**Subject: Amendment #1**  
**Interim Remedial Measure #5 Work Plan**  
**Former Sperry Remington Site – North Portion (NYSDEC #c808022)**  
**777 South Main Street**  
**City of Elmira, Chemung County, NY**

On behalf of Unisys Corporation (Unisys), Geosyntec Consultants, Inc. and its New York engineering affiliate, B&B Engineers & Geologists of New York, P.C. (collectively, Geosyntec) are submitting this first amendment (Amendment #1) to the Interim Remedial Measure #5 (IRM #5) Work Plan for the Former Sperry Remington Site – North Portion (Site #c808022) (Site) in Elmira, New York. The Site is located at Elmira High School (EHS). IRM #5 is being conducted in accordance with the Brownfields Cleanup Agreement (BCA) for the Site executed on 23 March 2017 with the consent of Elmira City School District (ECSD). The revised Final (100%) IRM #5 Work Plan was submitted on 24 November 2020 and was given conditional approval by the New York Department of Environmental Conservation (NYSDEC) on 4 December 2020. IRM #5 construction began with mobilization on 7 December 2020. The purpose of IRM #5 is to conduct soil removal and former industrial sewer removal in the EHS Football Field Complex

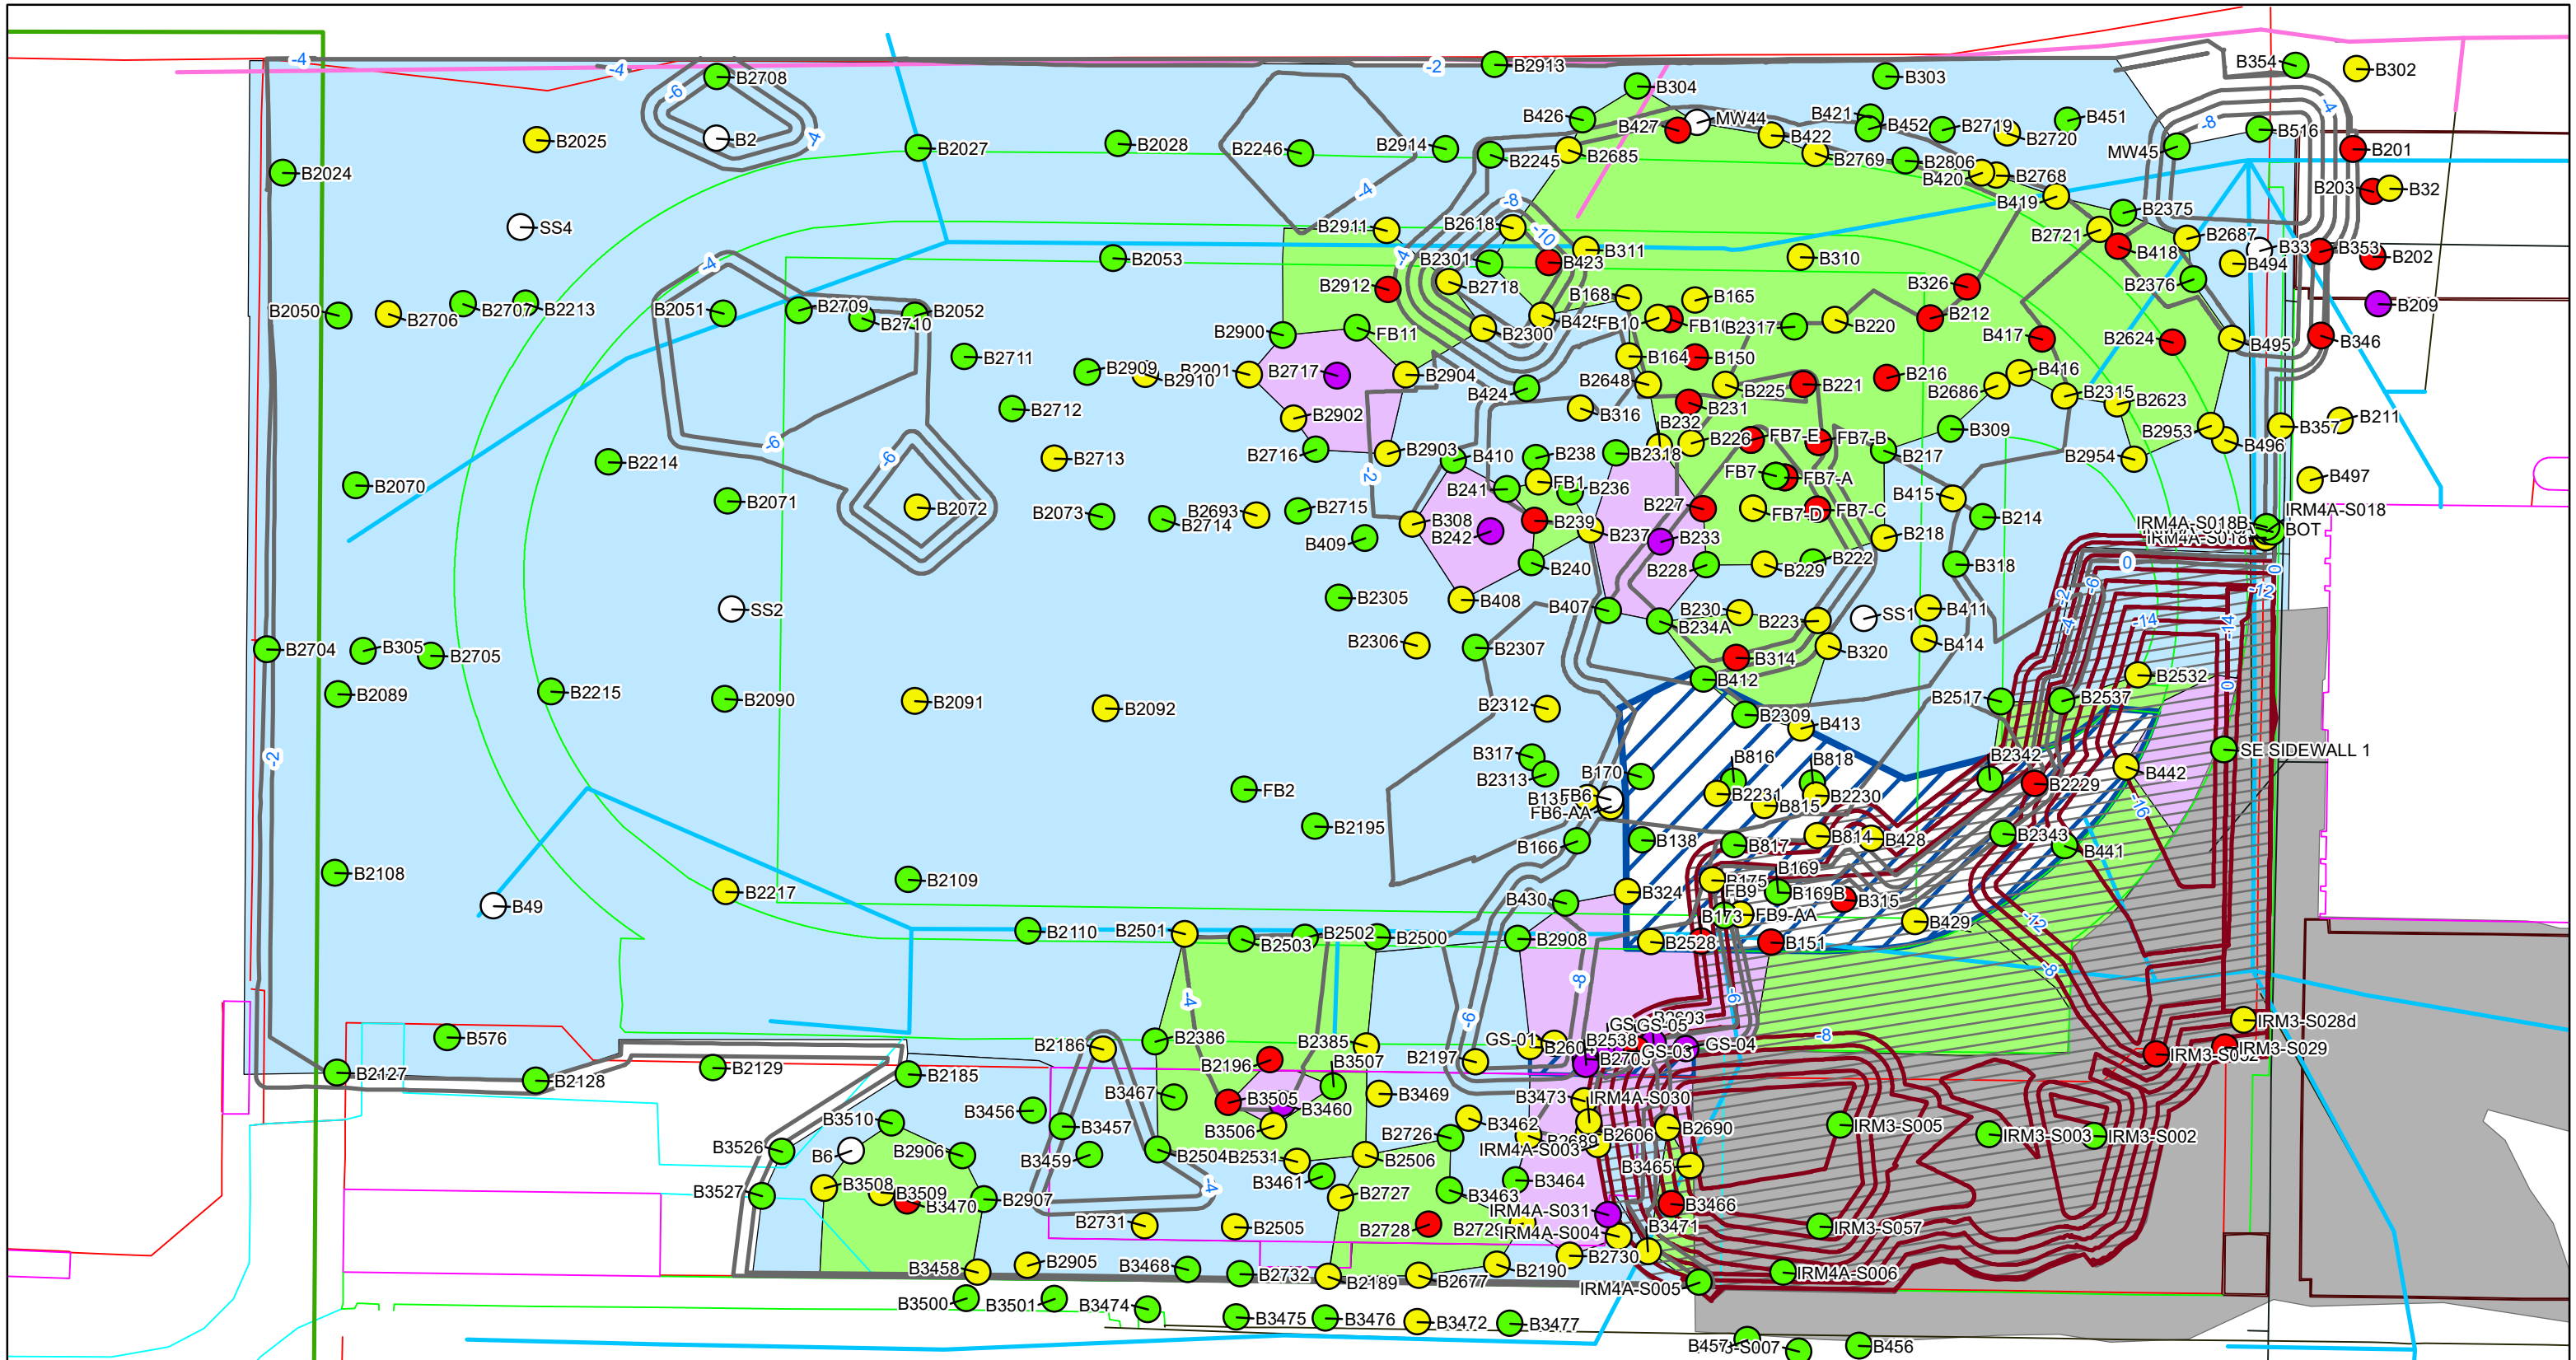
The analytical results for confirmation samples collected from the IRM #4A excavation exceeded the IRM cleanup goals presented above along the boundary between the IRM #4A and IRM #5 limits of excavation. Soil management areas within the IRM #5 excavation have been modified on Sheets 5 to 7 of the Construction Drawings (Attachment 1) for the 0 to 2 ft , 2 to 4 ft and 4 to 6 ft excavations. Updated Figures

5A, 5B, 6A and 6B present the updated extent of PCBs and metals for those excavations. Soils will be managed based on final disposition in accordance with the IRM #5 Work Plan.

DATE: DECEMBER 2020  
PROJECT NO. MN08321  
DOCUMENT NO.  
FILE NO. MN08321F1014  
FIGURE NO. 14

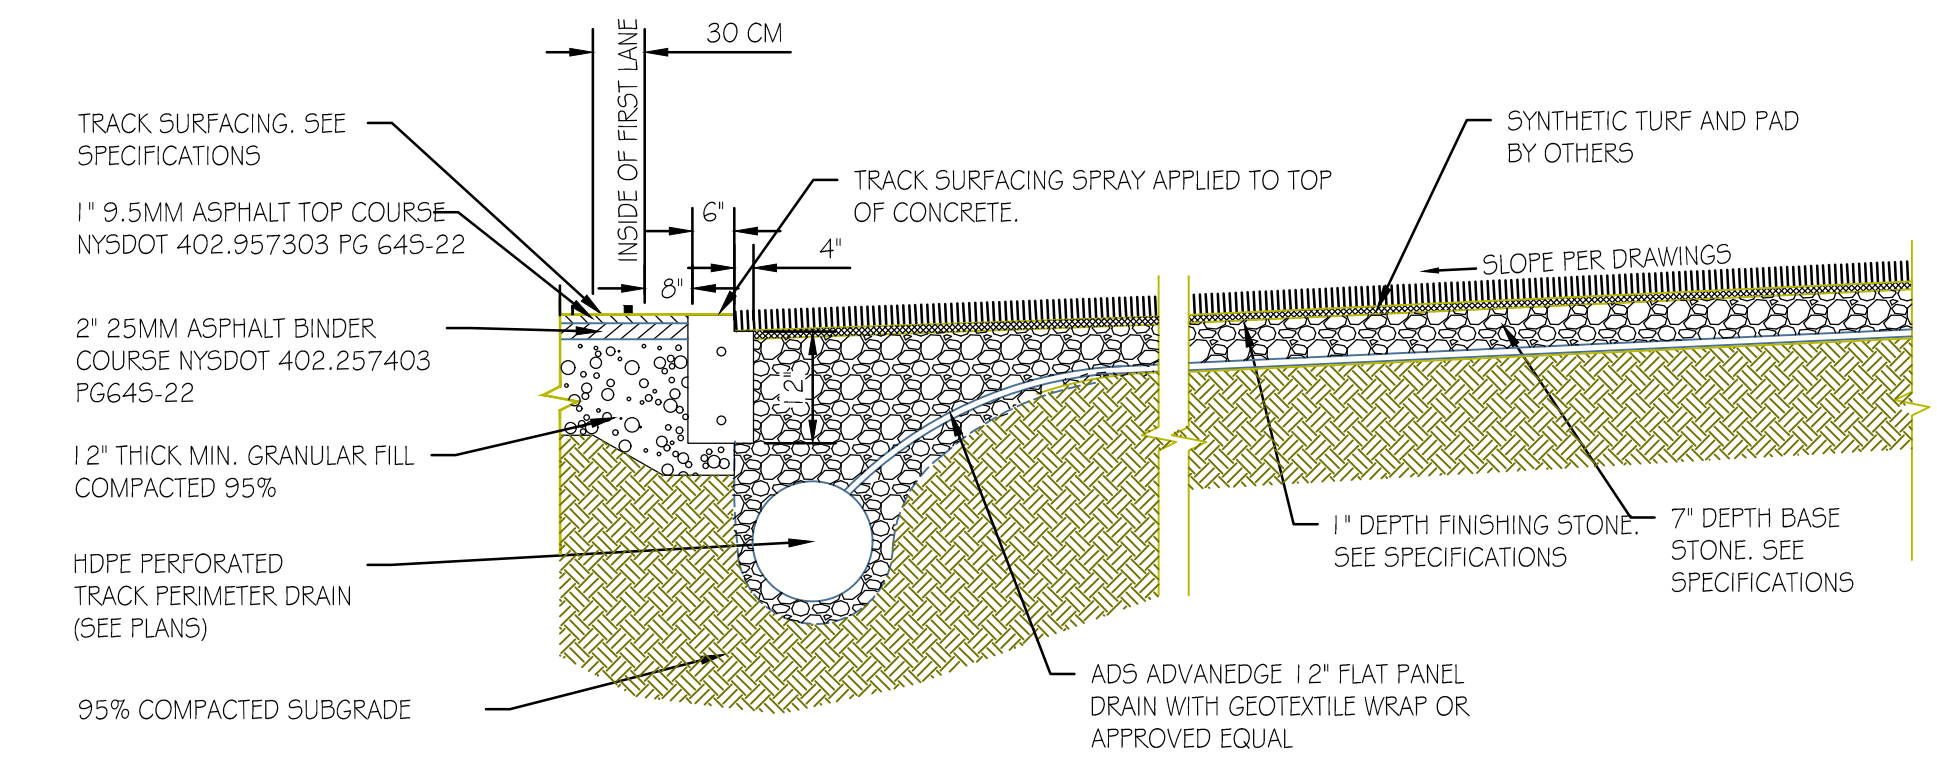
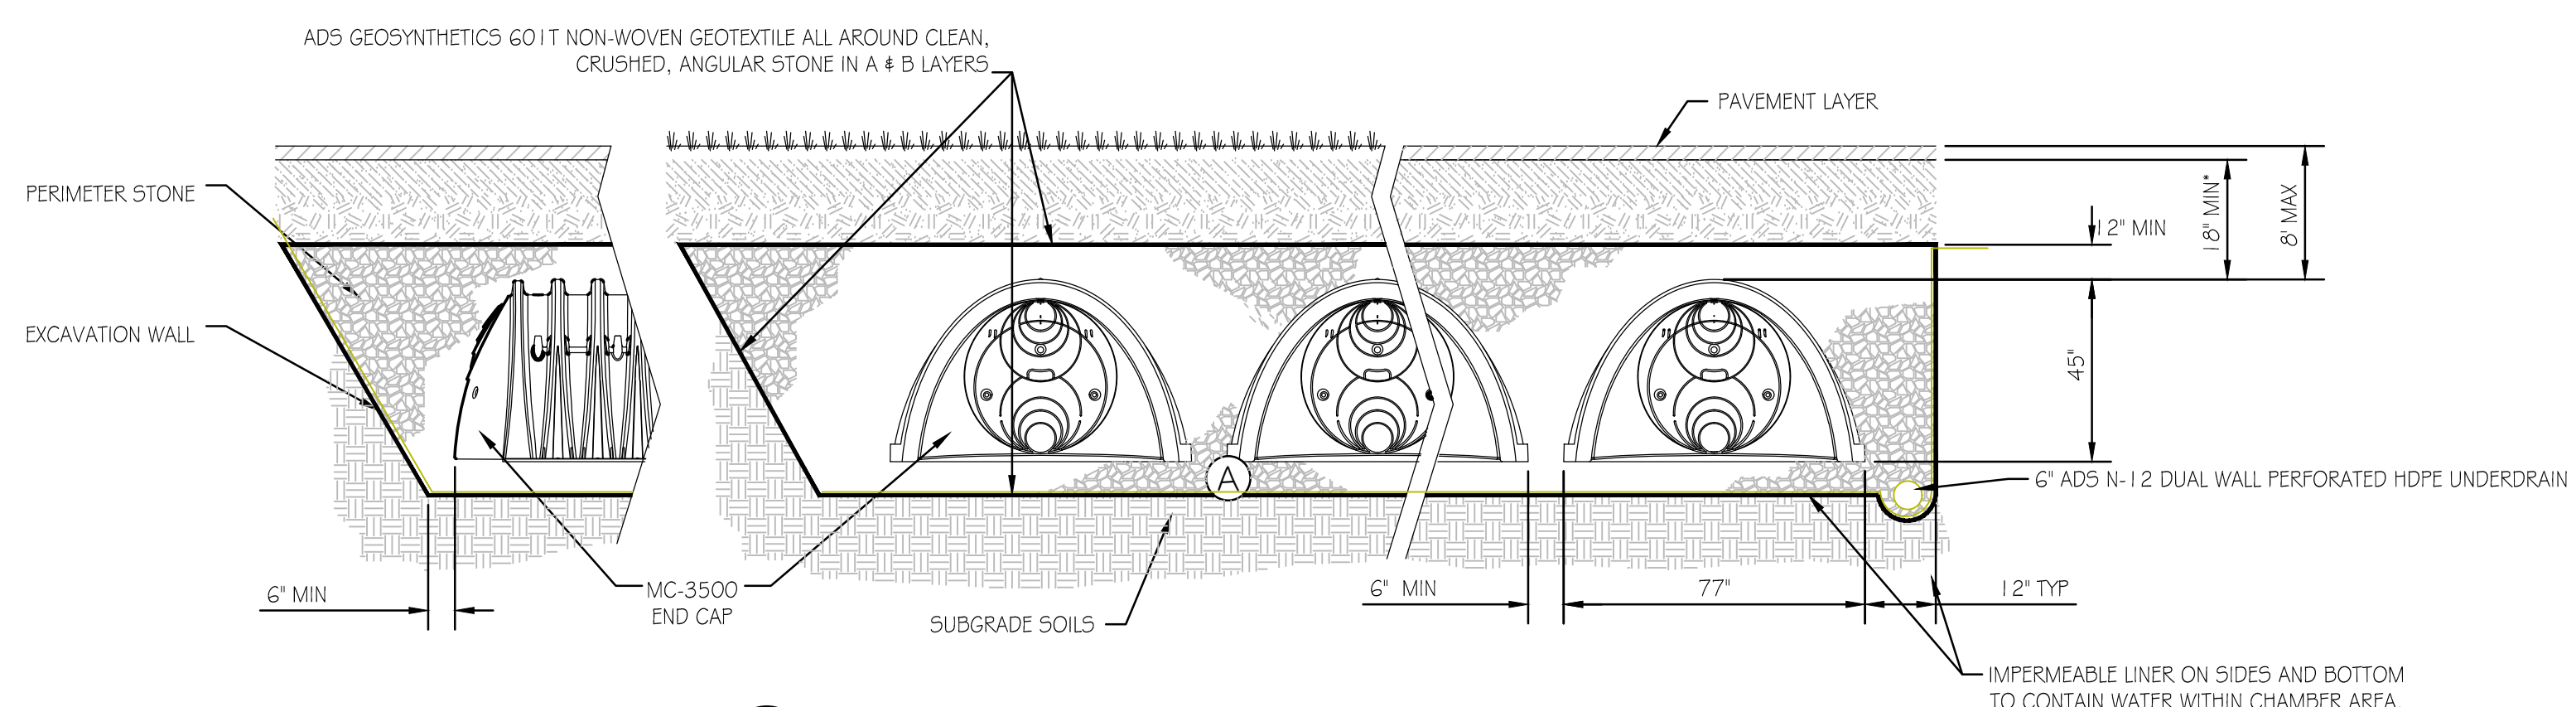
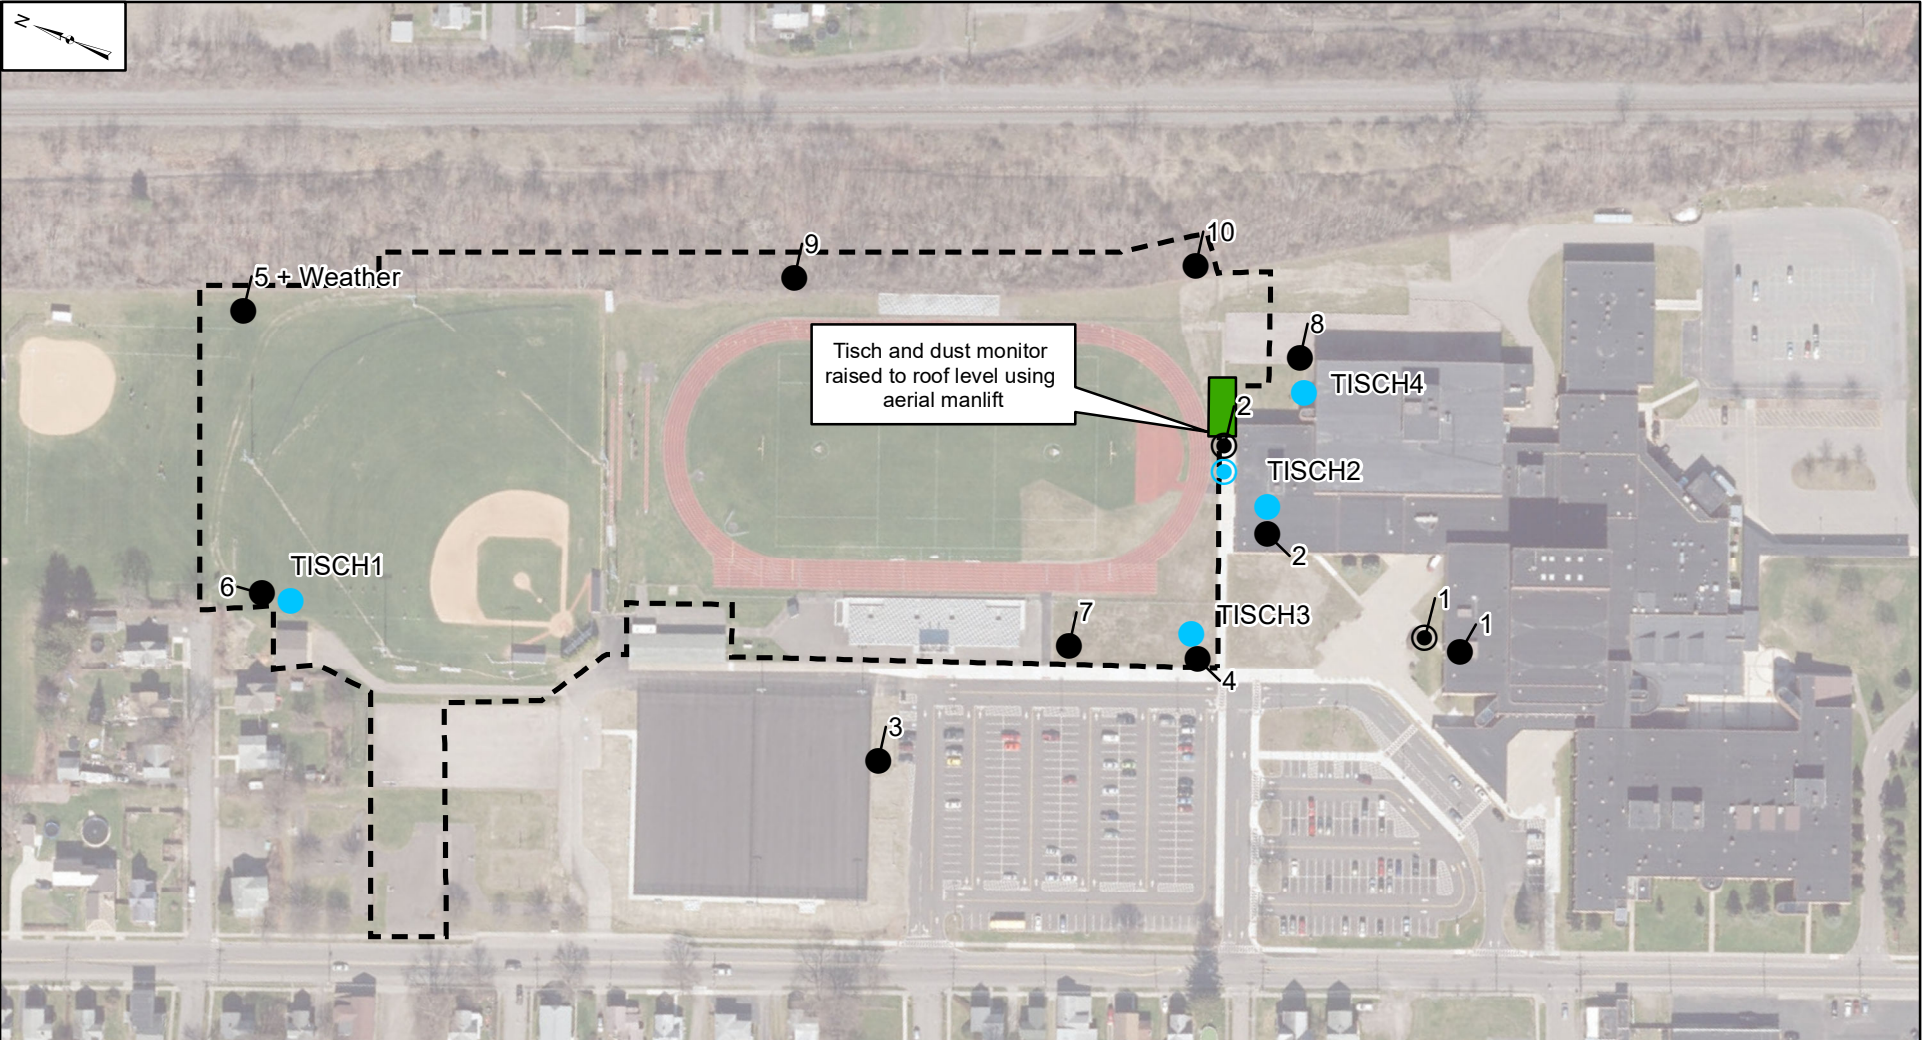
Drawings (Attachment 1) present intermediate final grades for the top of backfill using NYSDEC-approved reuse soils that will two (2) feet below the final grades of the EHS stadium to be constructed by ECSD and final restoration grades for turnover of the FFC to ECSD that may include NYSDEC-approved imported fill, respectively. The final soil cover system to be implemented within the FFC as an engineering control will include soil/turf, concrete and asphalt. An updated Figure 14 presents the limits of the FFC cover system engineering control and typical sections.
